Model: Model AI-C1	Date: 07-Nov-07	No.: RD009001j
---------------------------	-----------------	----------------

Subject: Firmware Release Note: NetworkDocBox		Prepared by: T. Hirakawa	
From: 2nd Tech Service Sect., MFP/Printer Tech Service Dept.			
Classification:	<input type="checkbox"/> Troubleshooting	<input type="checkbox"/> Part information	<input type="checkbox"/> Action required
	<input type="checkbox"/> Mechanical	<input type="checkbox"/> Electrical	<input type="checkbox"/> Service manual revision
	<input type="checkbox"/> Paper path	<input type="checkbox"/> Transmit/receive	<input type="checkbox"/> Retrofit information
	<input type="checkbox"/> Product Safety	<input checked="" type="checkbox"/> Other ()	<input checked="" type="checkbox"/> Tier 2

This RTB has been issued to announce the firmware release information for the **Network DocBox**.

33.Duplex Unit 1 (D009/D011/D012/D013/D091/D092)

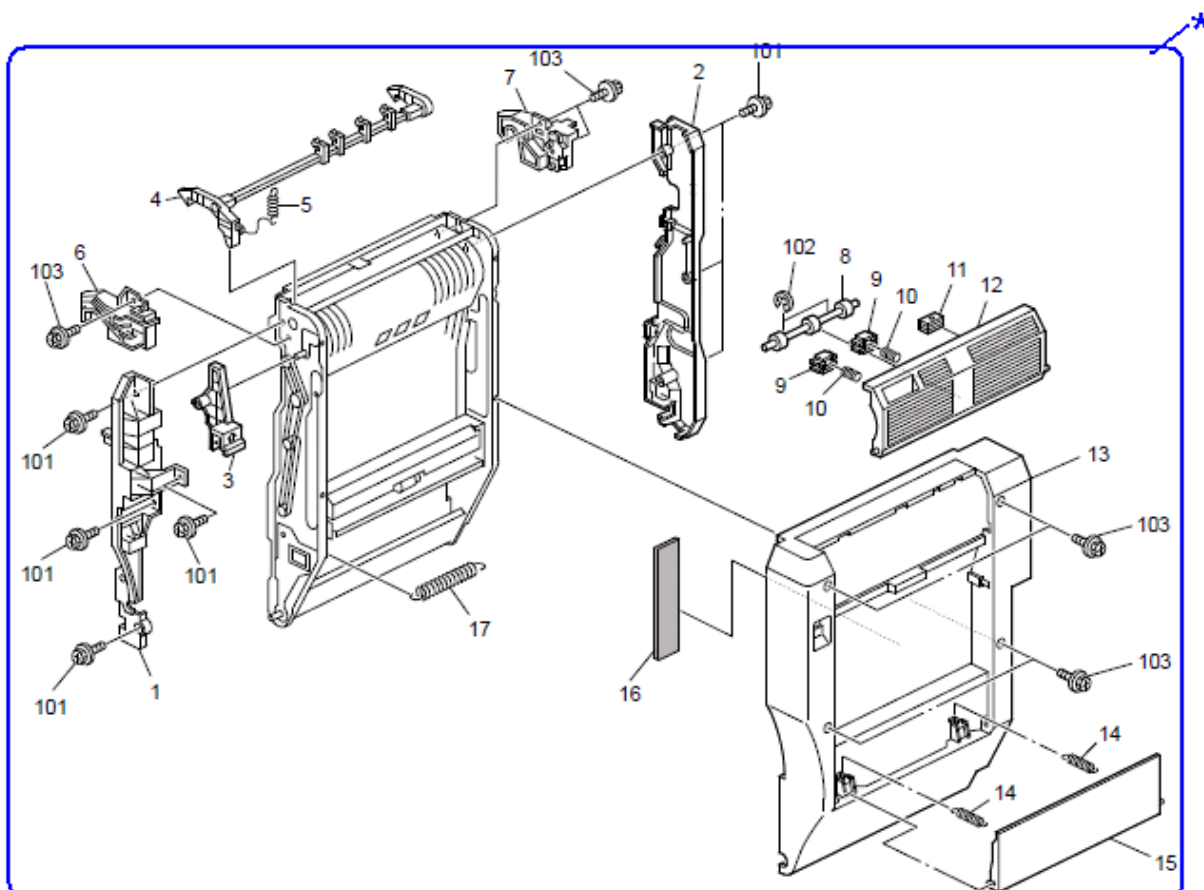
As per field request, the following part was newly added as a service part.

8.Original Transfer 1 (D009/D011/D012/D013)

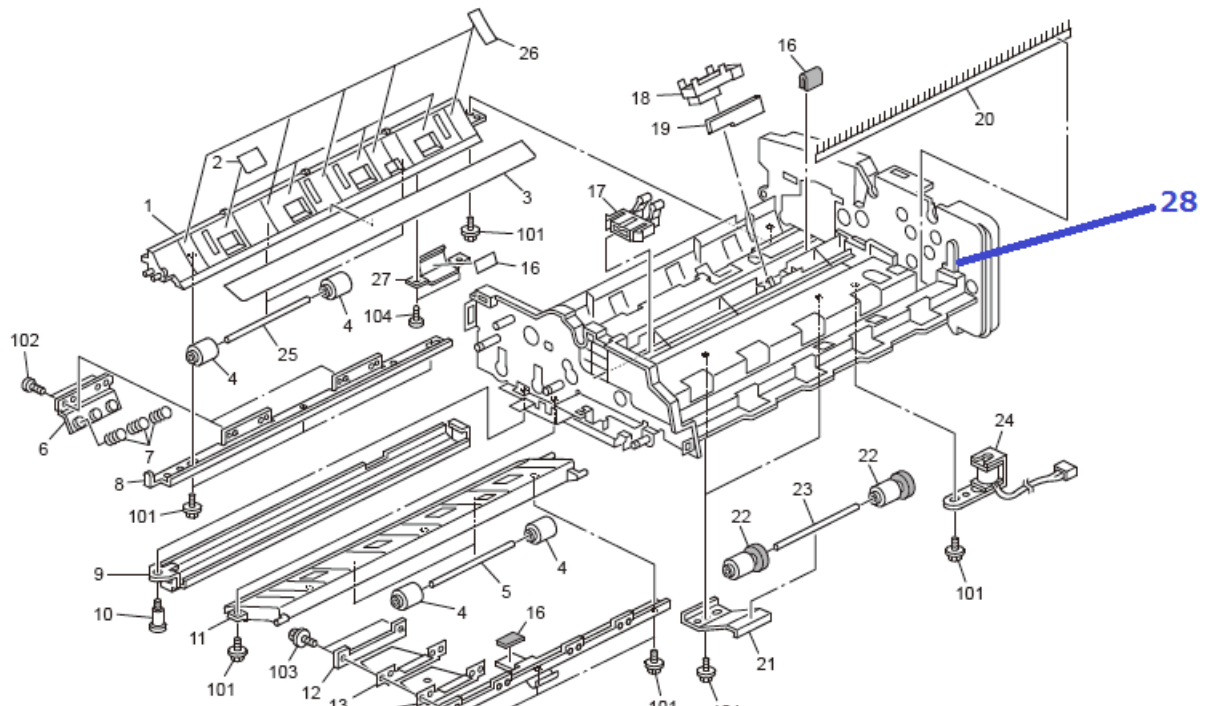
As per field request, the following part was newly added as a service part.

21.Paper Feed Section (D009/D011/D012/D013)

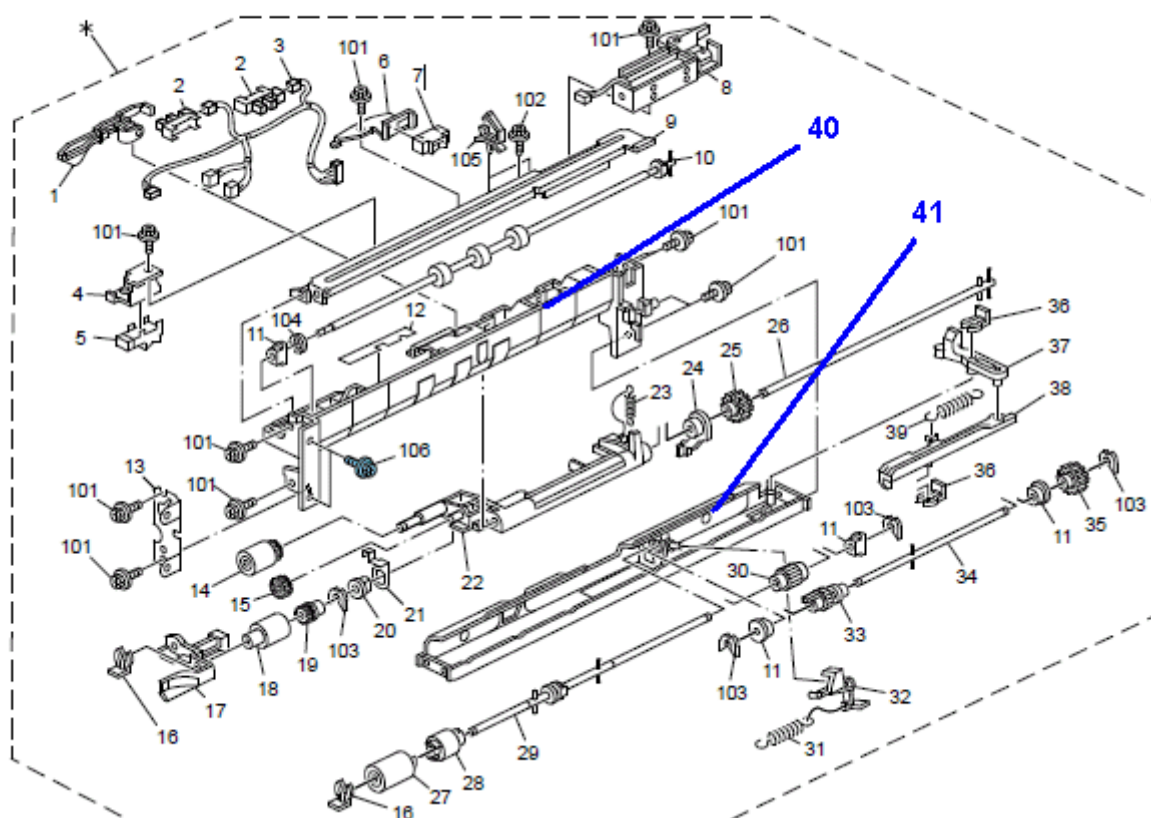
As per field request, the following part was newly added as a service part.

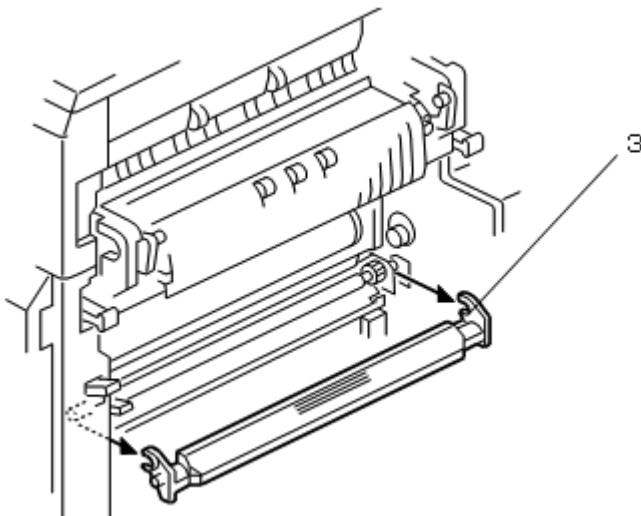
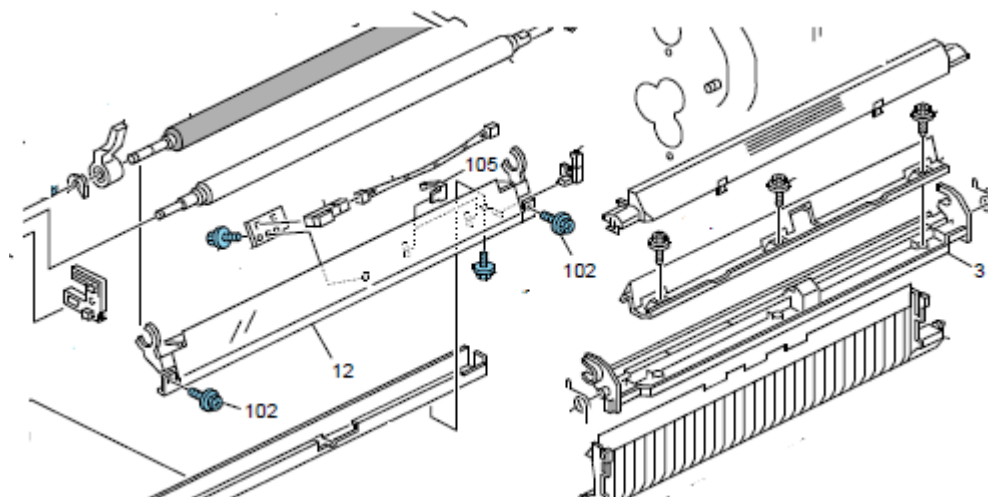
Current method:

The guide plate is fixed by mounting the ends of the shaft and fixing it in place with spring pressure.

- Co-fastening ribs were added to the guide plate (index #3 below).
- This guide plate and registration lower guide plate (index #12) are fastened to each other using a screw (after the shaft is attached).
- The length of this fastening screw was increased from 6mm to 8mm (index #102)

48.Electrical Section 5 (D009/D011/D012/D013)

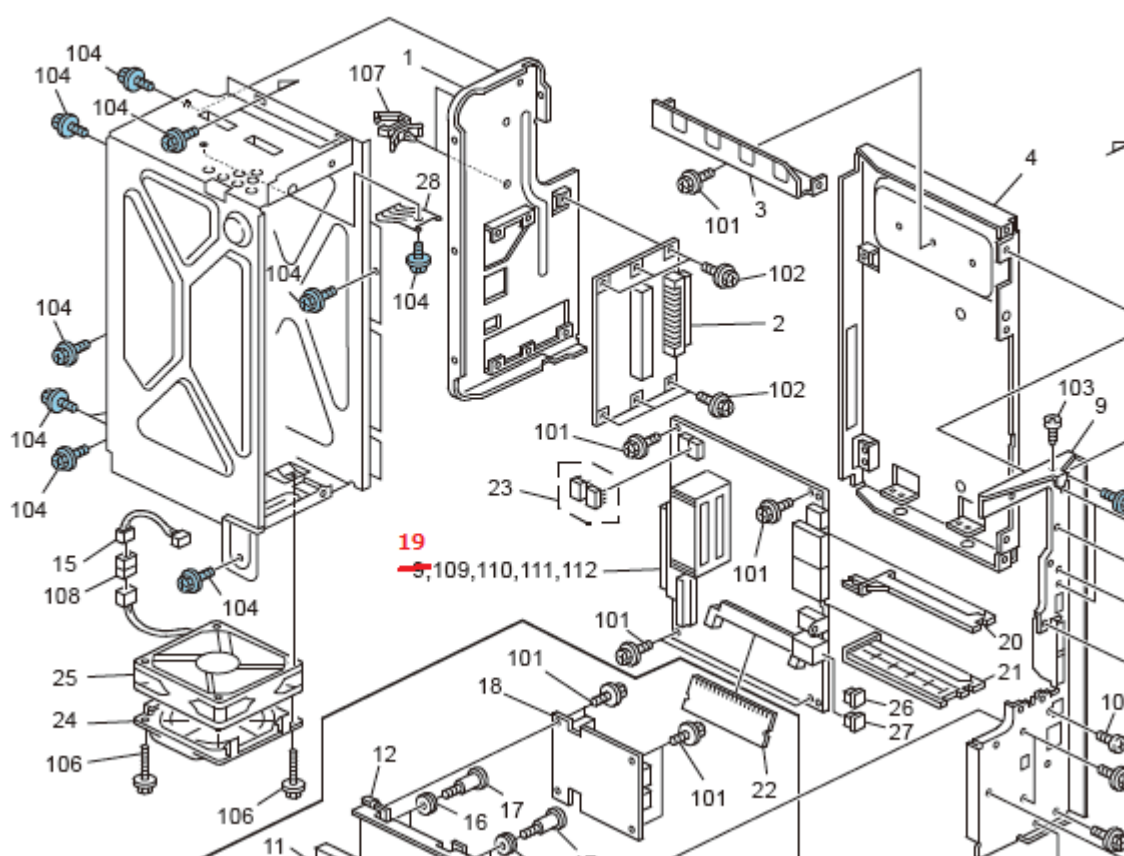
Change/Reason: The index shown below was corrected.

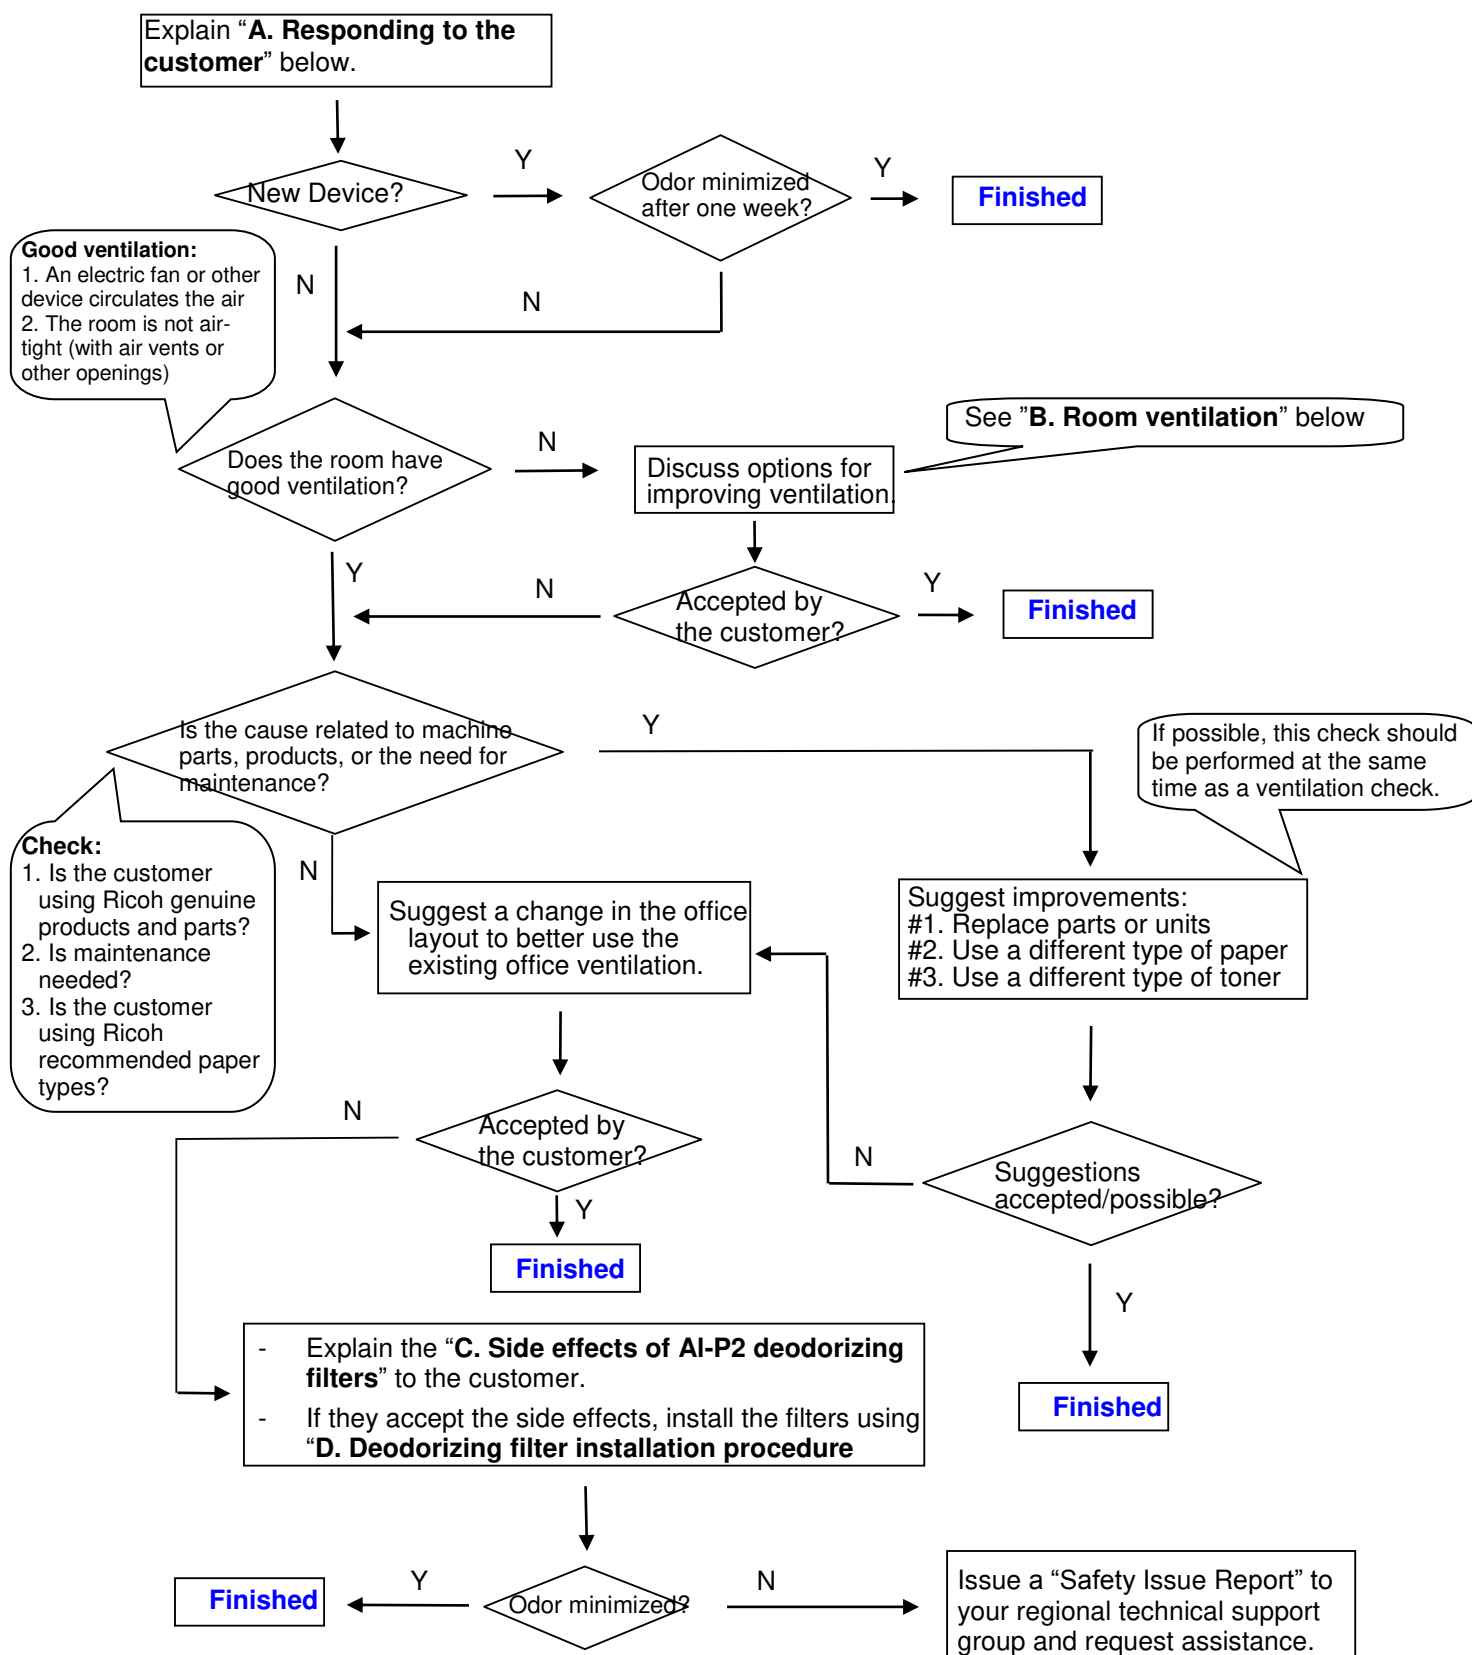
Change: Deodorizing filters were newly added as service parts for the AL-C1/AL-C1.5/AL-C2/AL-P1/AL-P2.

Reason: To meet the requests of customers who may report strange odors on these models.
